**DALLAS CENTER GRIMES SCHOOL
DISTRICT ADMINISTRATION BUILDING**

**ENGINEERING STUDY
2405 W 1ST STREET
GRIMES, IA 50111**

**Thomas C. Hardinge, P.E., C.E.M.
Mechanical Engineer**

Figure 3: DCG Admin Building Partial Ductwork Plan

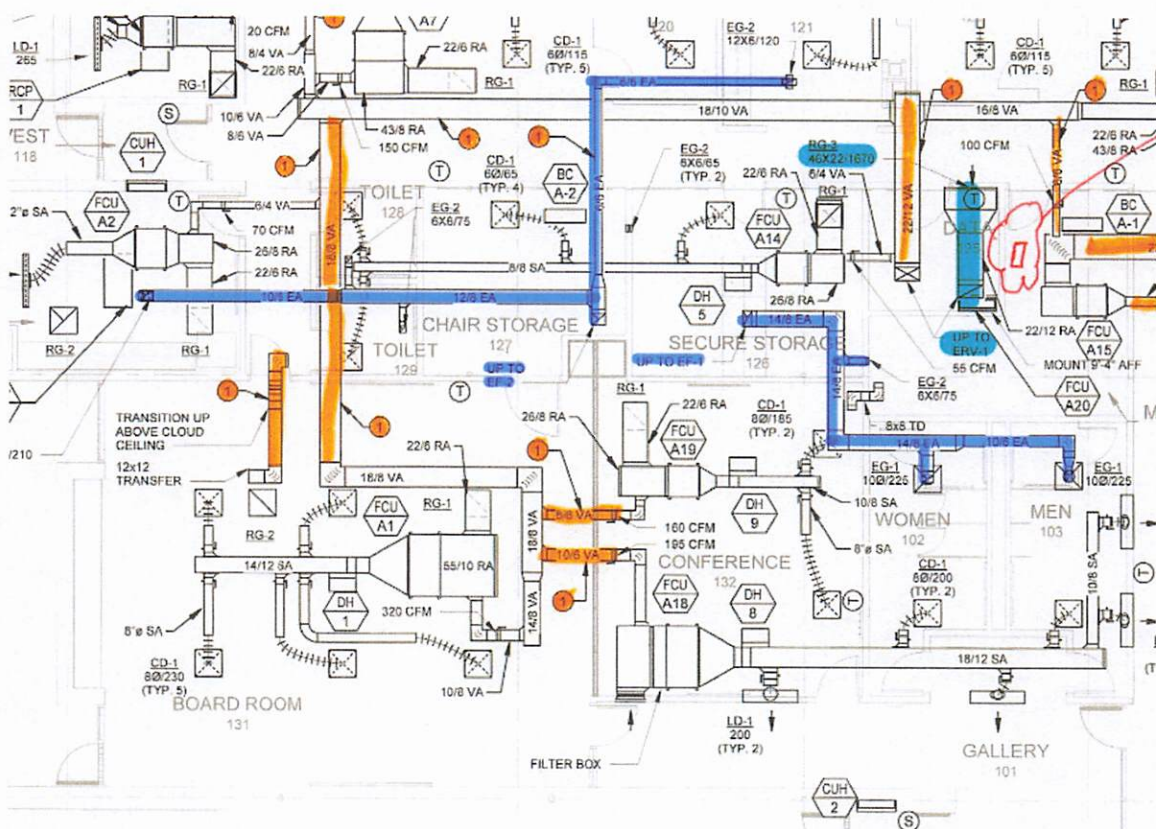
The DOAS unit at the DCG Administration Building is designed to deliver 1,800 CFM of supply air while returning 1,800 CFM from the building. The building's dehumidification is based on the unit running at full capacity. However, two separate exhaust fans are installed and ducted independently, which likely restricts the airflow returning to the DOAS unit.

In the diagram above, the exhaust air is shown in purple, and the DOAS return air is shown in blue. Typically, all exhaust air, including general restroom exhaust, should be routed back to the DOAS unit, especially when it includes an enthalpy wheel. This setup allows the unit to maintain proper building pressure while operating at its design capacity. However, when the exhaust duct is routed separately, the air is removed without passing through the enthalpy wheel, limiting its effectiveness. As a result, the DOAS unit's capacity is reduced, which could also lead to building pressure issues.

Baker Group recommends that the first step be to route all general exhaust air to the DOAS unit. This will ensure that the enthalpy wheel operates as designed, delivering the necessary supply air and providing the correct DOAS discharge air temperatures for full dehumidification throughout the building.

1. Disconnect and remove the existing roof-mounted exhaust fans
2. Revise the current exhaust air ductwork to route all exhaust to the DOAS unit
3. Install one (1) in-line booster fan for exhaust air
4. Rebalance building airflow to be controlled through the DOAS unit

Figure 4: Proposed Exhaust Ductwork Modifications

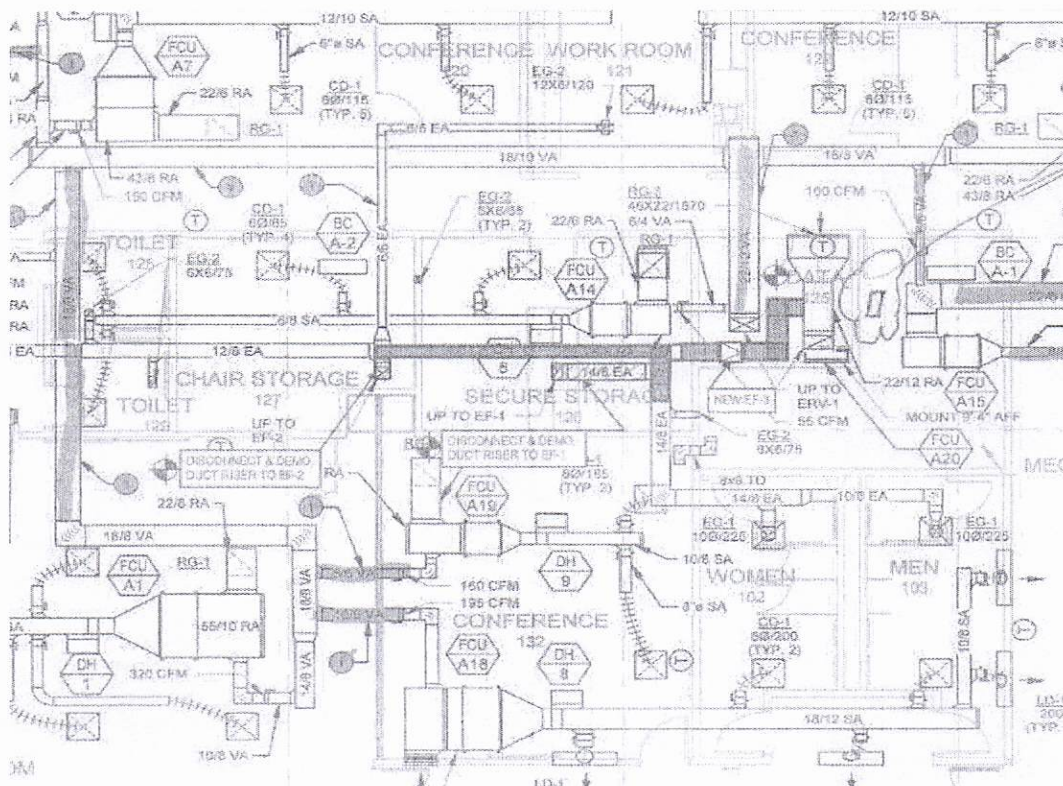
The new exhaust ductwork installation is shown below (in green):

This repair / system modification is needed to make the system operate properly. Currently the way the system runs, it is causing comfort issues as well as creating an environment in the summer where mold spores can grow. Because this modification is directing the exhaust air through the DOAS unit it will reduce energy consumption as well. The reduced energy alone will not pay for the modification, but the modification will allow the building to operate at the proper airflow conditions.
